ENGINEER'S REVIEW
DIBBLE ENGINEERS, INC.
__X__ No Exceptions Taken
_____ Note Markings
_____ Revise & Resubmit
By DEI/MKW Date 1/10/23
ENGINEER'S REVIEW IS FOR GENERAL CONFORMANCE TO THE DESIGN CONCEPT AND CONTRACT DOCUMENTS. REVIEW OF THE SPECIALTY STRUCTURAL ENGINEERS (SSE) DESIGN IS FOR CONFORMANCE TO DESIGN CRITERIA AND COMPATIBILITY WITH THE DESIGN OF THE BUILDING AND DOES NOT RELIEVE THE SSE OF RESPONSIBILITY FOR THE SPECIALTY STRUCTURAL DESIGN. REVIEW SHALL NOT BE CONSTRUED AS RELIEVING THE CONTRACTOR FROM COMPLIANCE WITH THE PROJECT PLANS AND SPECIFICATIONS, NOT DEPARTURES THEREFROM. THE CONTRACTOR REMAINS RESPONSIBLE FOR DETAILS AND ACCURACY; FOR CONFIRMING AND CORRELATING ALL QUANTITIES AND DIMENSIONS; FOR SELECTION OF FABRICATION PROCESSES AND TECHNIQUES OF ASSEMBLY; AND FOR PERFORMING WORK IN A SAFE MANNER.

SHAKE SHACK
(SHACK #1317)

SEISMIC RESTRAINT GENERAL NOTES & DETAILS

SEISMIC/WIND ANCHORAGE CALCULATIONS FOR EQUIPMENT ON ROOF CURBS

SEISMIC/WIND ATTACHMENT REQUIREMENTS FOR:
MAU-1

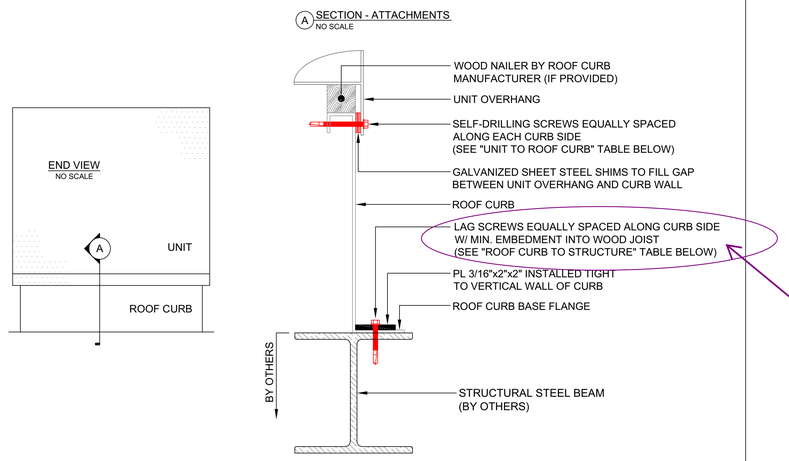
Not wood. Use self-tapping screws for steel.
